REVISION NOTE

TITLE: TA800UXE底座

DWG NO
TA-071012-029

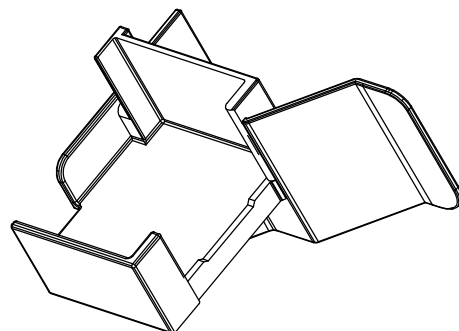
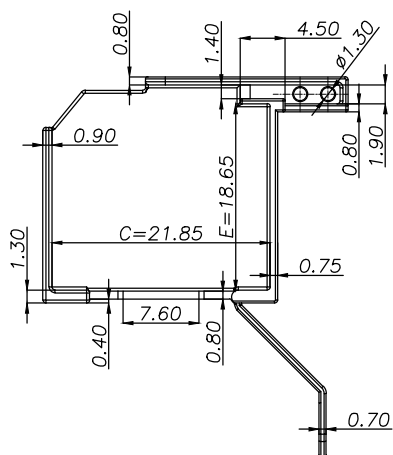
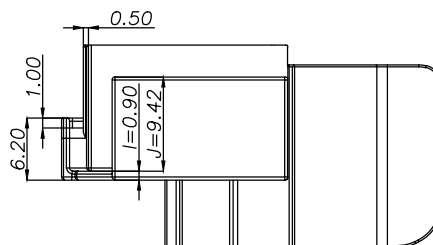
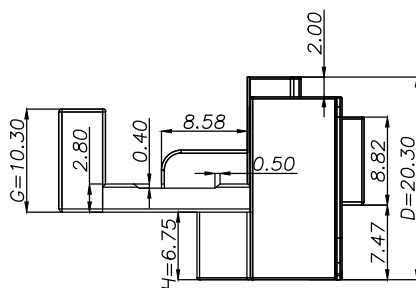
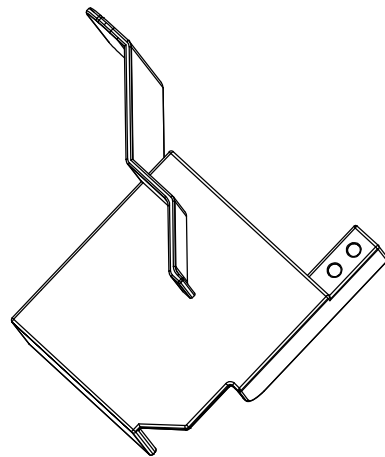
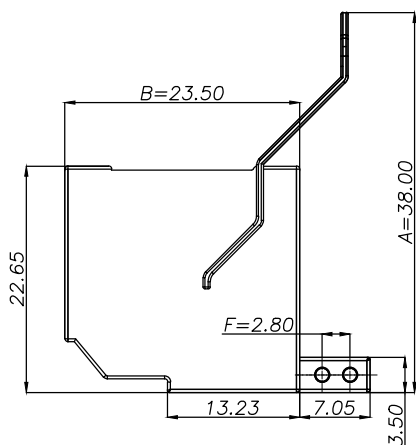
2020.06.29	1. 高度2.80挡板由外向内移动0.40, 厚度不变。
2020.04.27	1. 高度2.80挡板上, 开深0.40宽7.60的槽。
2020.04.02	1. 底部壁厚由0.70修改为0.90, 2. 增加高2.80, 厚度0.80挡板。
